United Nations ECE/TRANS/WP.29/2018/38

Proposal for Supplement 3 to the 05 series of amendments to UN Regulation No. 22 (Protective helmets)

Submitted by the Working Party on Passive Safety*

Supplement 3 to the 05 series of amendments to UN Regulation No. 22 (Protective helmets)

Type approval scheme (Flow chart)

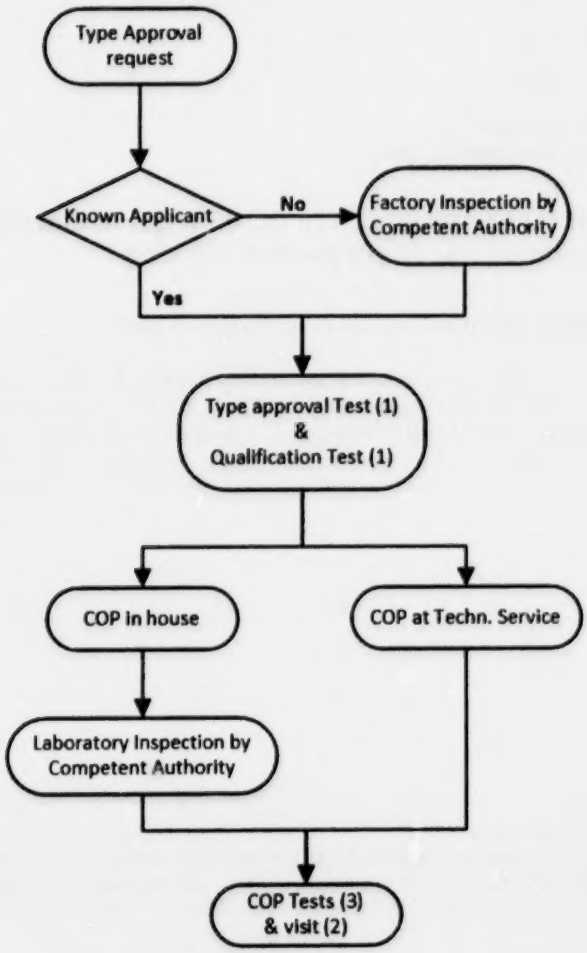
Annex 12, amend to read:

(1) To be carried out at the same technical service or the same accredited independent laboratory.

(2) Visit of the manufacturer for inspection and random sampling by the authority or technical service:

(a) If there is no ISO 9002* or an equivalent standard: 1 times a year

(b) If there is an ISO 9002* or an equivalent standard: 1 time every 1 to 2 years, depending on the results of the inspection.

(3) Tests in accordance to paragraph 10.5 and/or 10.6 on samples taken out of the production:

(a) If there is no ISO 9002*: of the authority or technical service during the visit of footnote 2 a) of the manufacturer between the visits of footnote 2 a)

(b) If there is an ISO 9002*: taken by the manufacturer, procedure checked during visit of footnote 2 b)"
